Annex 113A Description of cable clamp and test setup

113A.1 Overview

Figure 113A-3 - Cable clamp validation test configuration

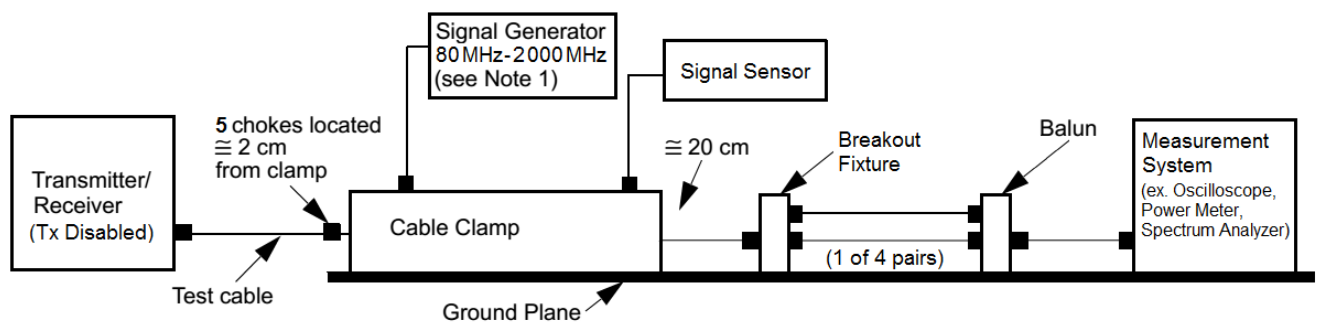
[Commenter's input: Is there a Note 1?]

Figure 113A-4 - Cable clamp test configuration

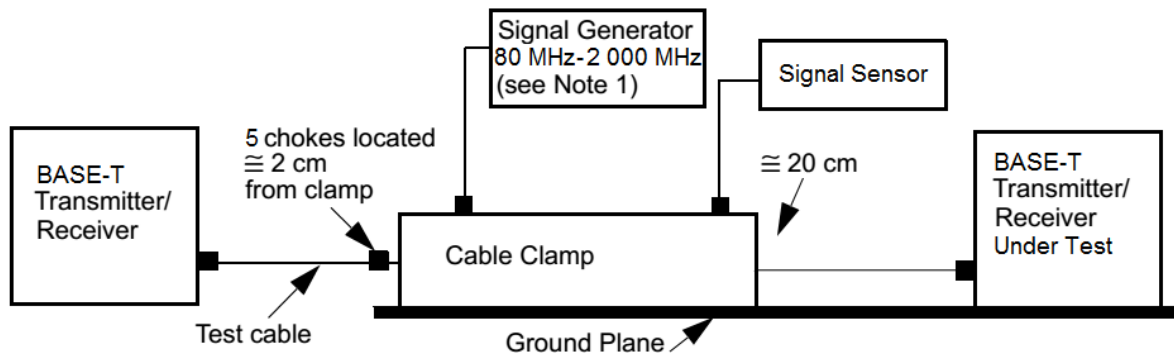
[Commenter's input: Is there a Note 1?]
